DRAINAGE PLAN
STA. 145+00 TO 150+00

FARRINGTON HIGHWAY INTERSECTION IMPROVEMENTS
AT NANAKULI AVENUE AND HALEAKALA AVENUE
Federal-Aid Project No. STP-093-1(22)

CONTRACT CHANGE ORDER NO. 27
Attachment 1

DRAINAGE PLAN
STA. 164+00 TO 168+00

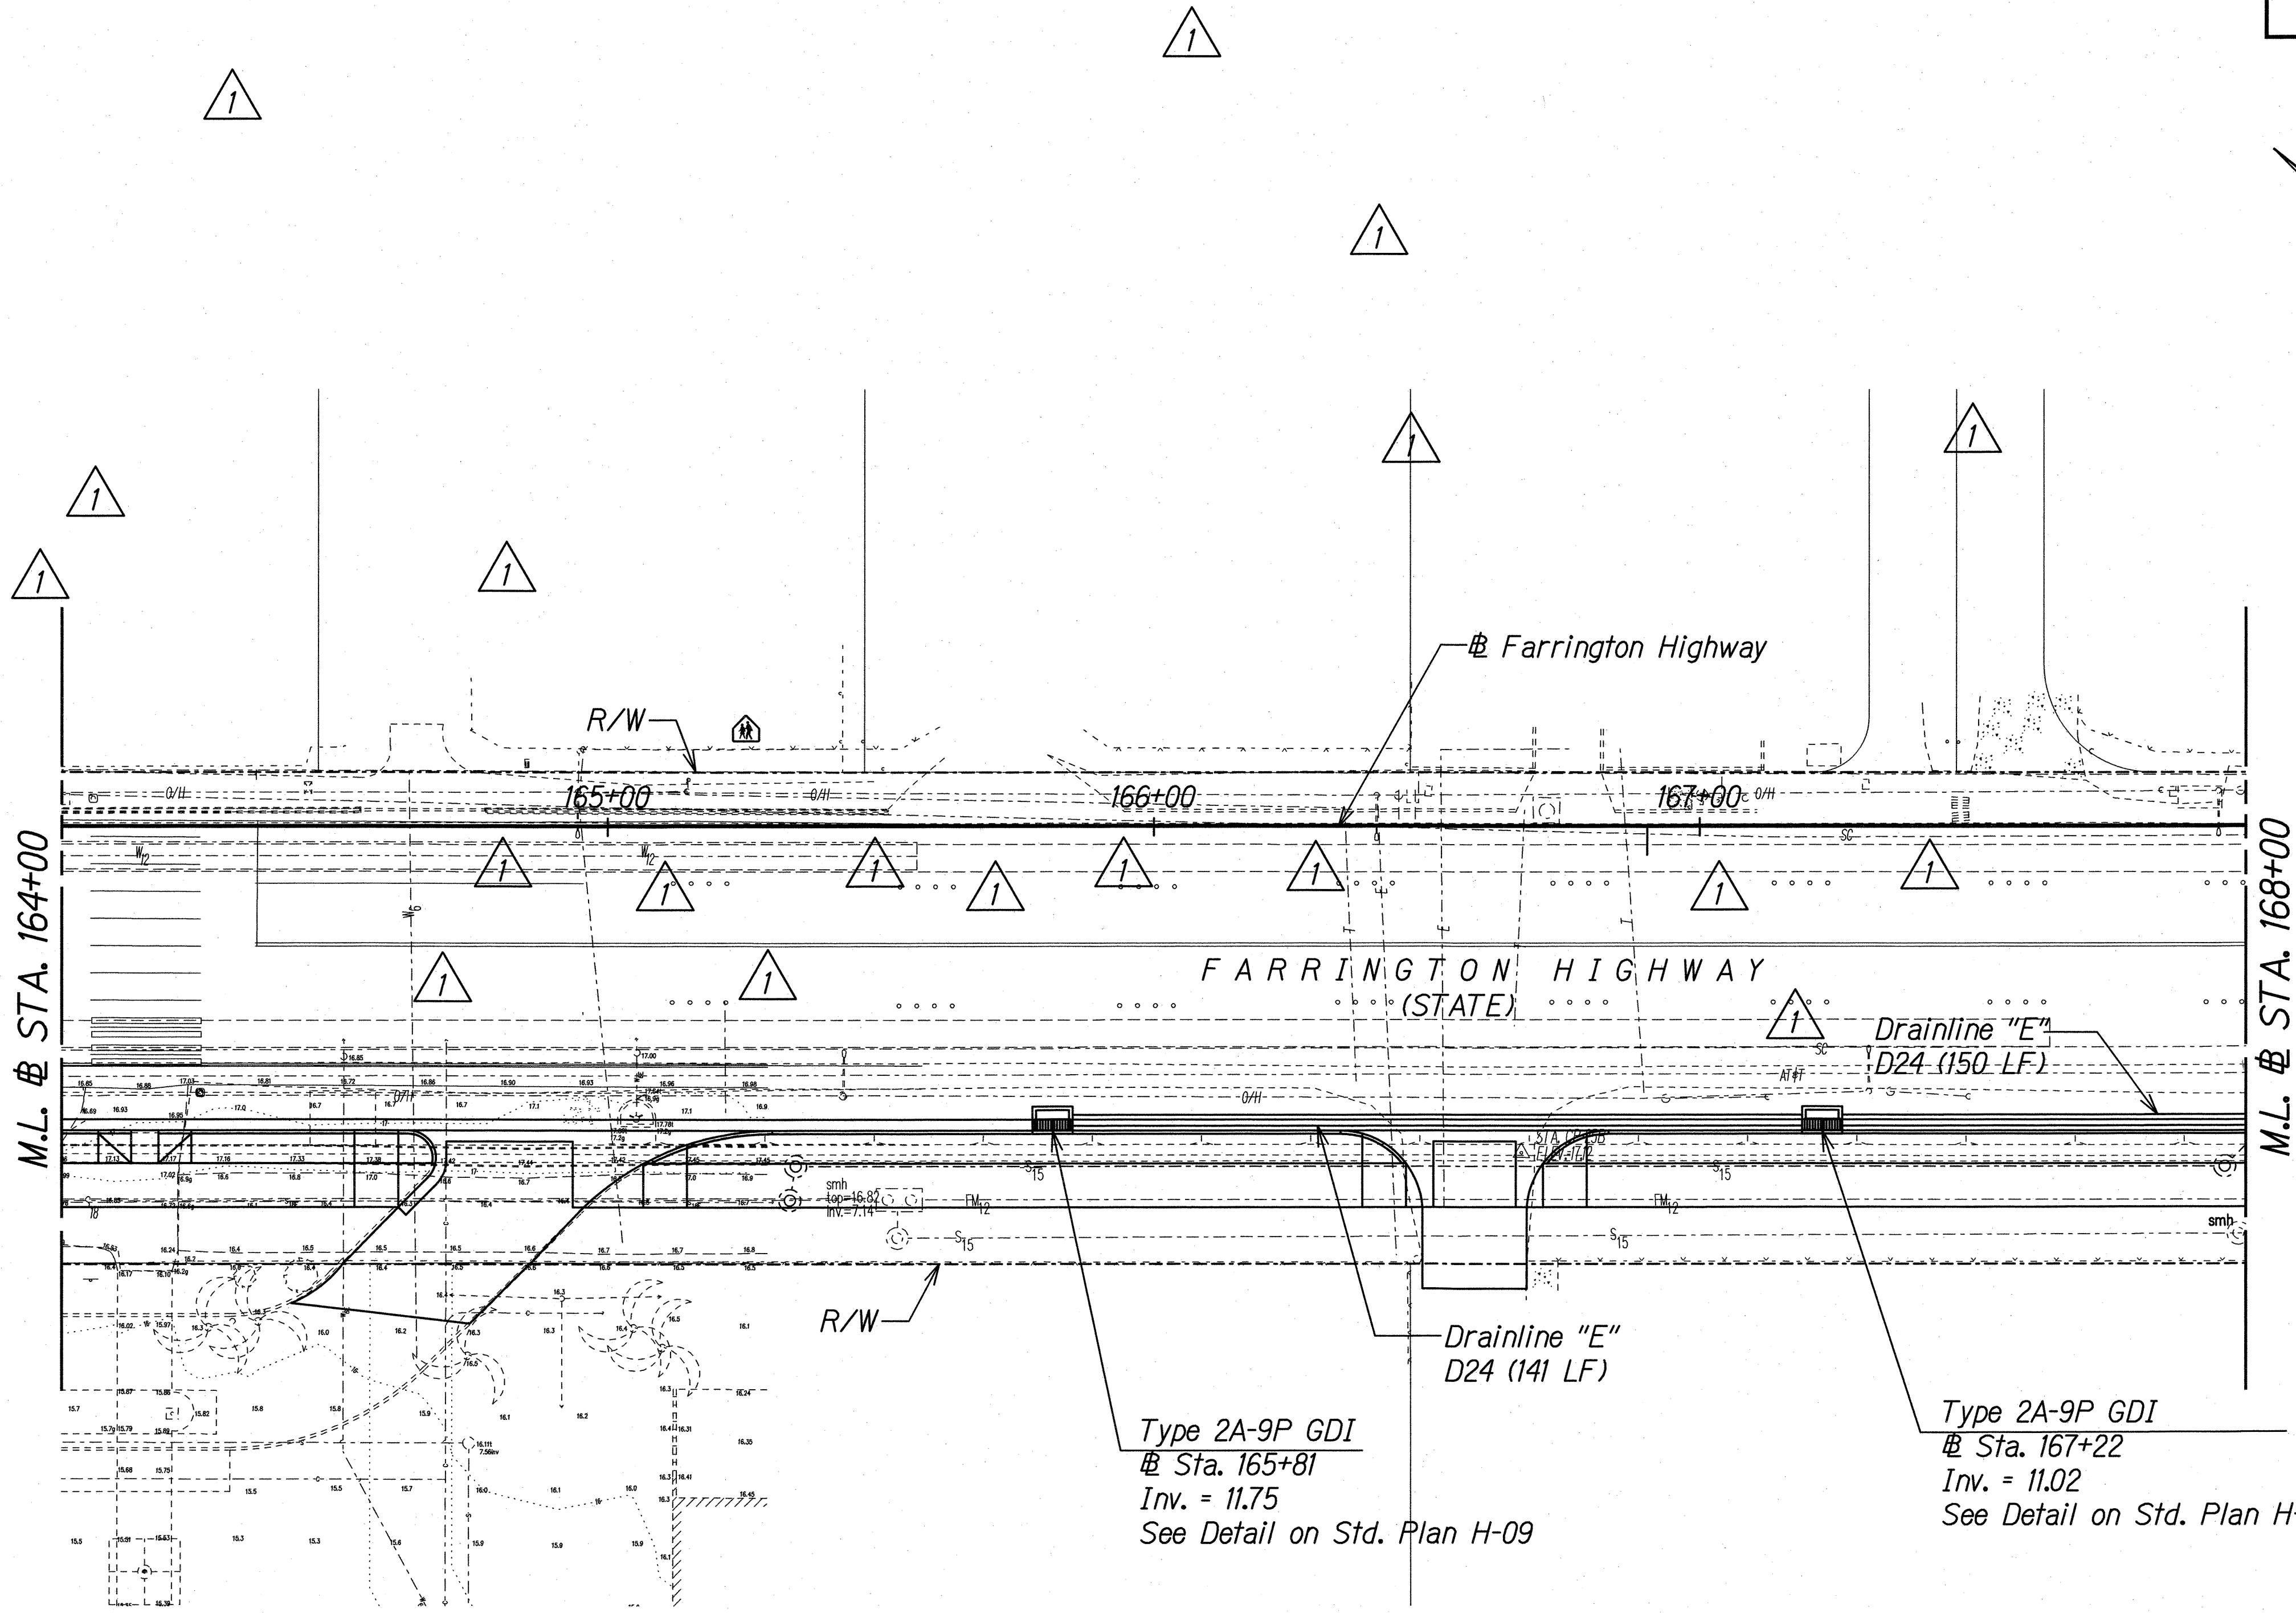
11/17/17	Deleted Drainline and Annotations
Date	Revision

DRAINAGE PLAN

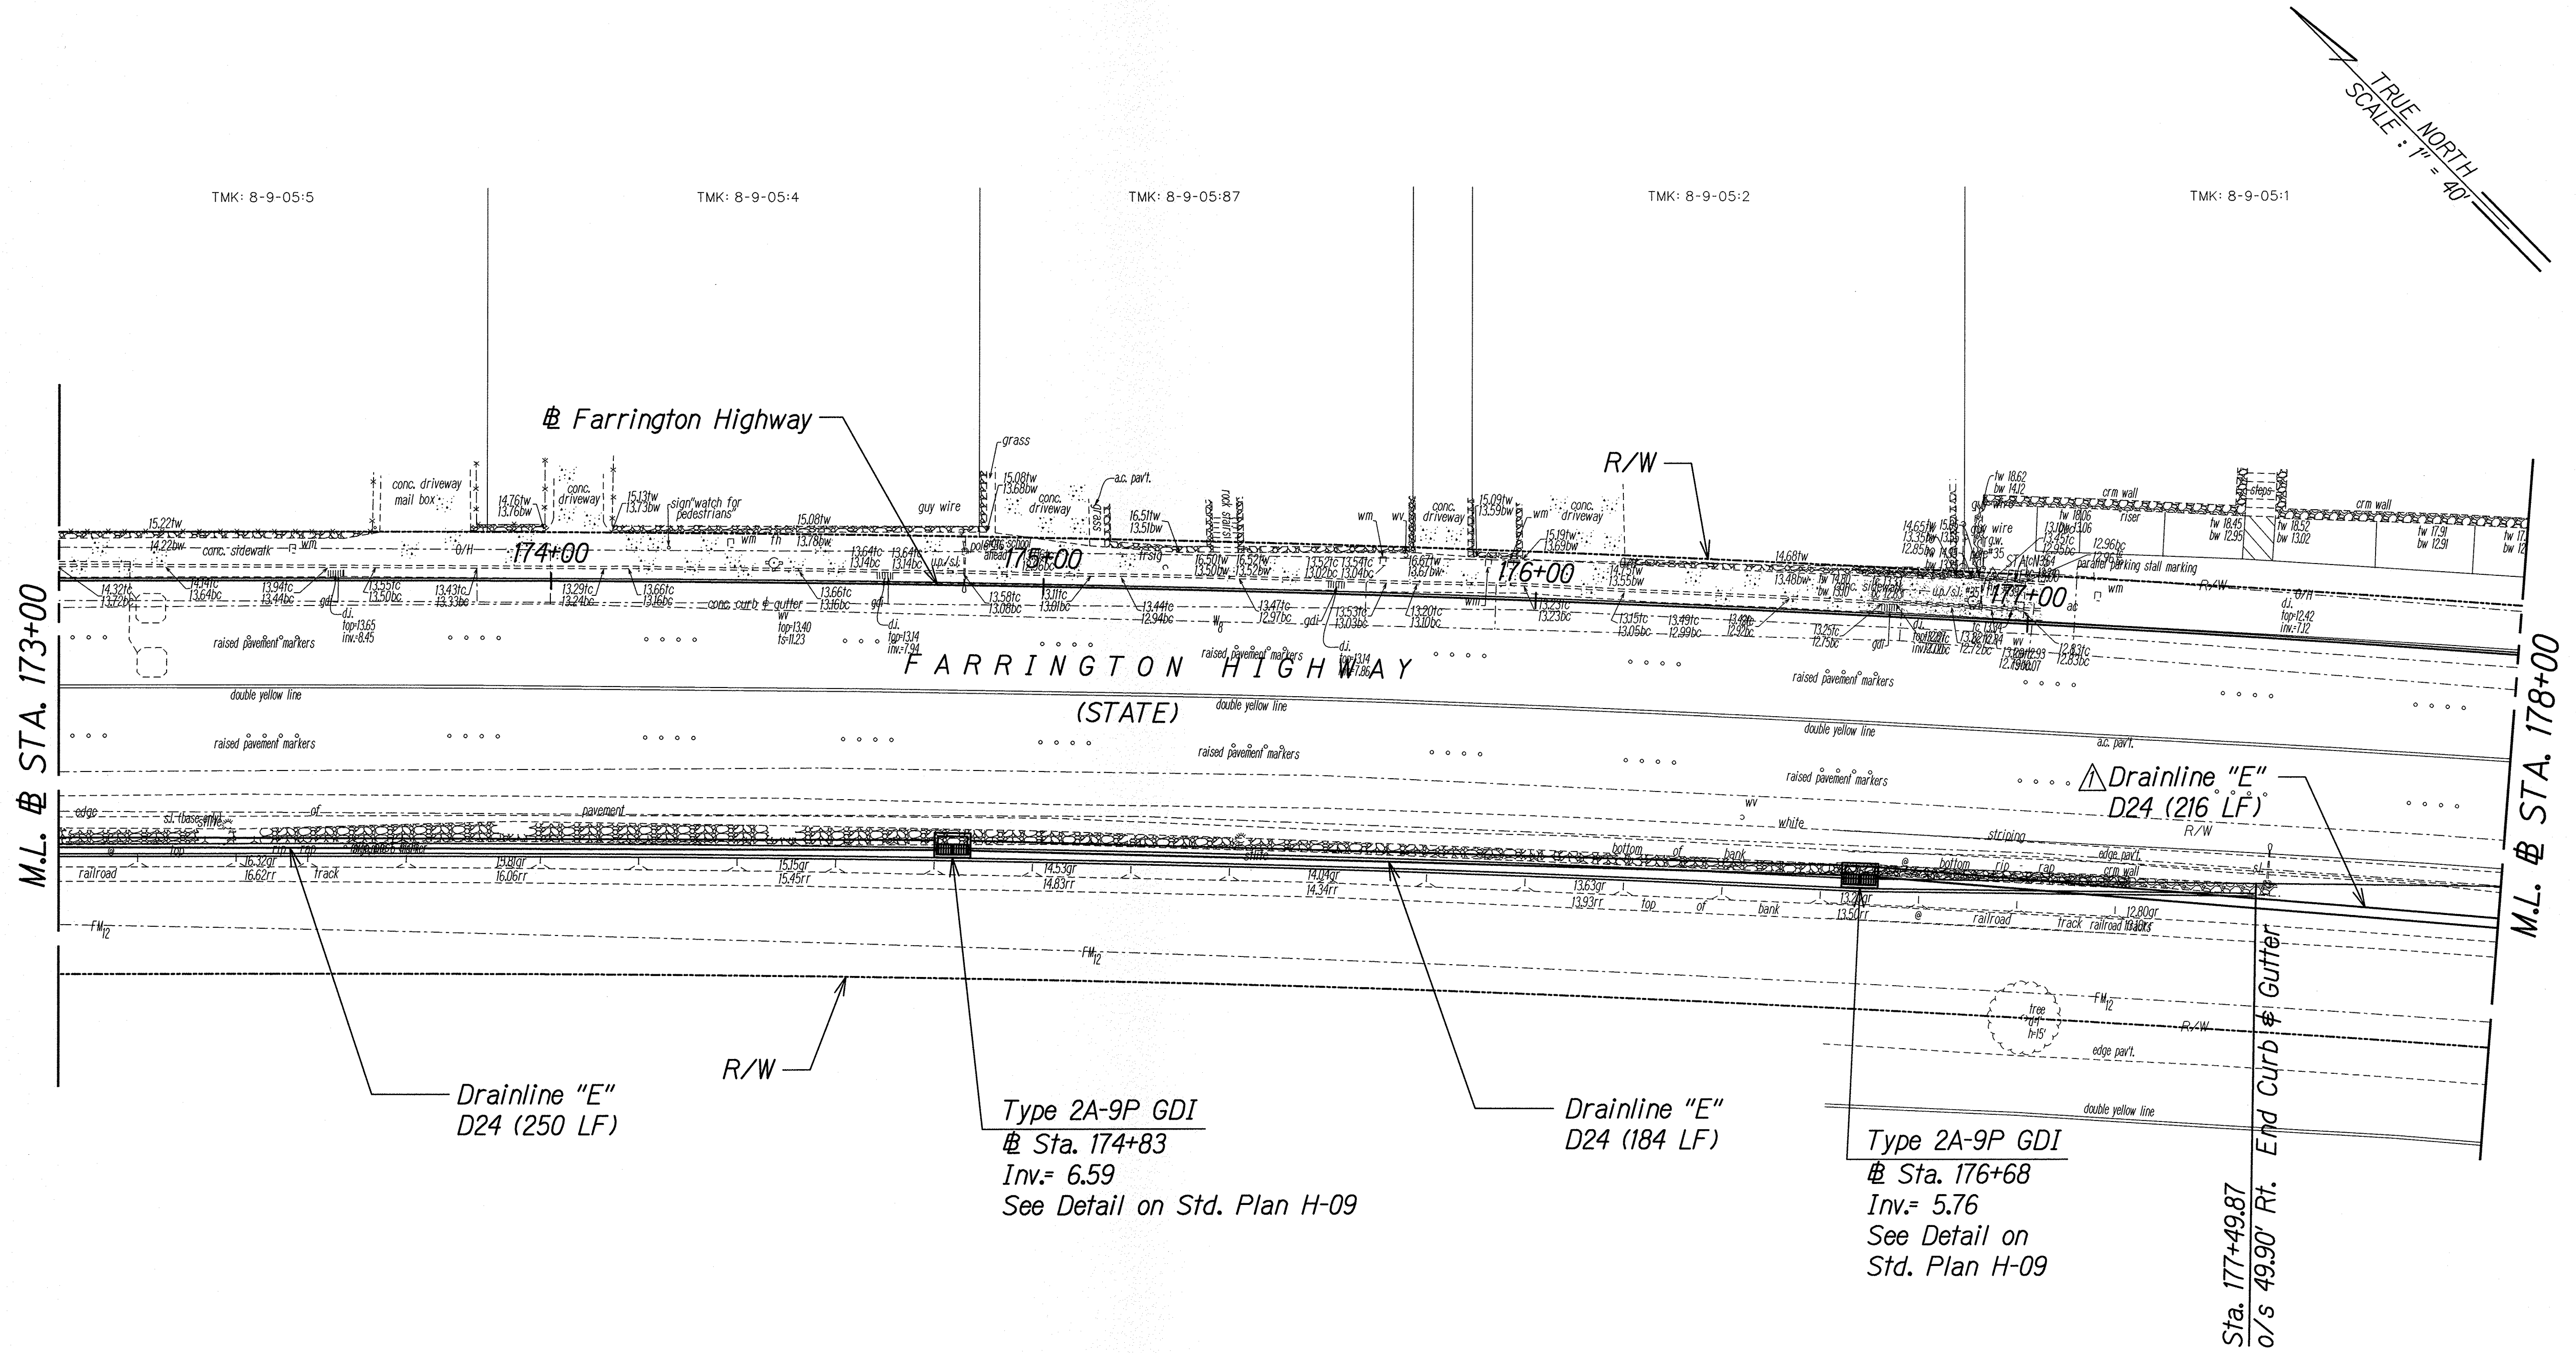
Revised Sewerline "E"

DRAINAGE PLAN

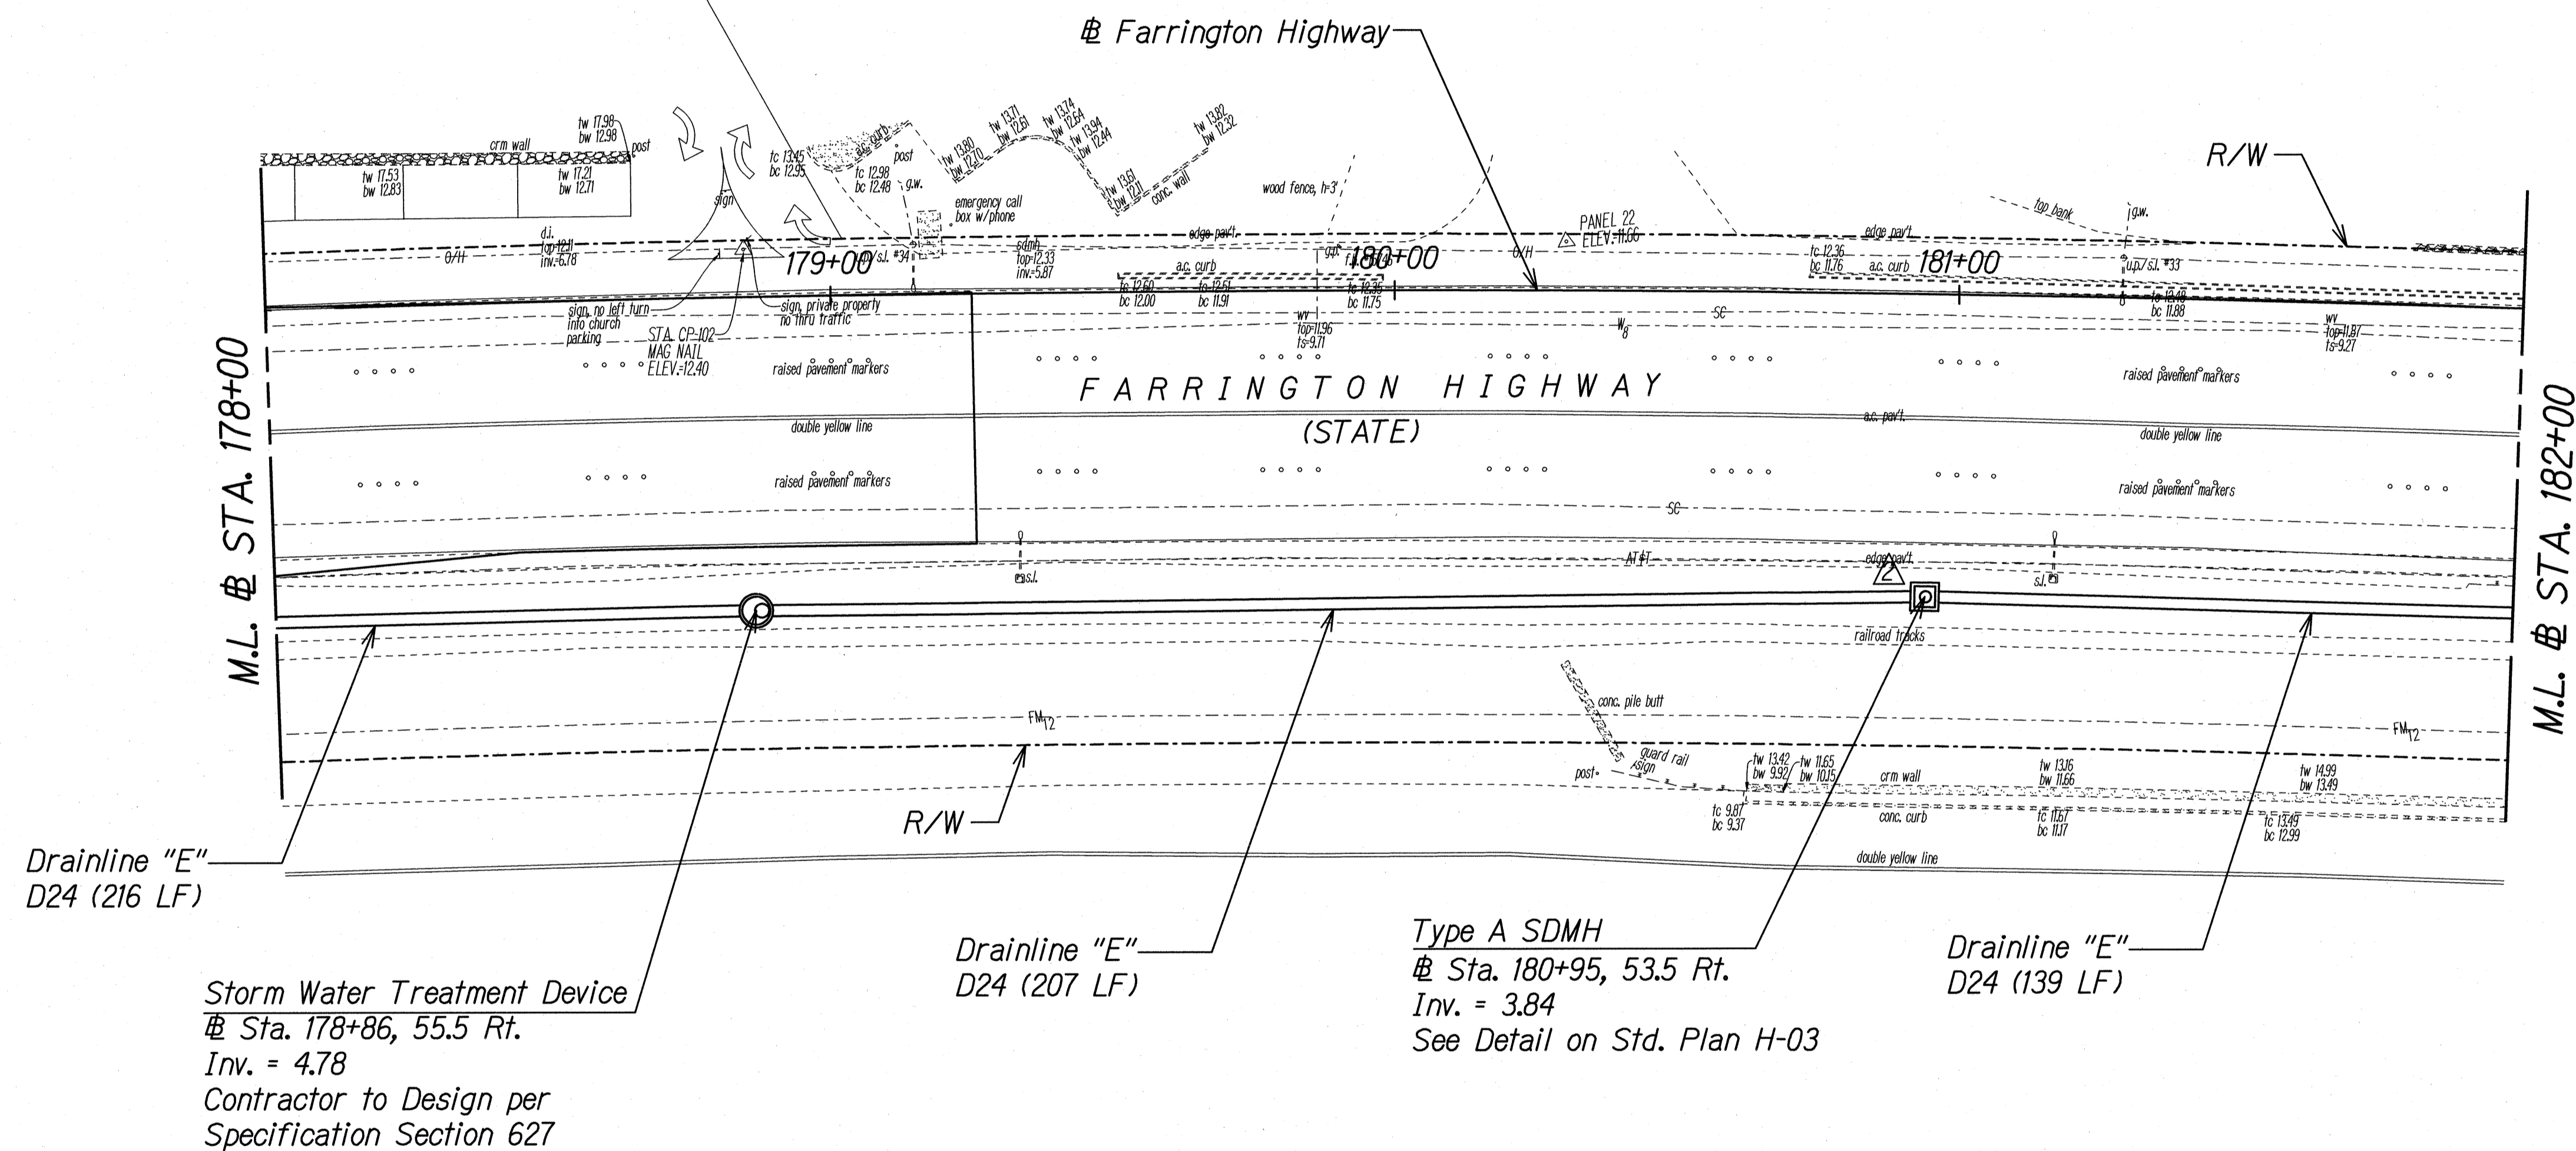
11/17/17	 Revised Drainline "E"
4/23/15	 Revised Drainline "E"
DATE	REVISION
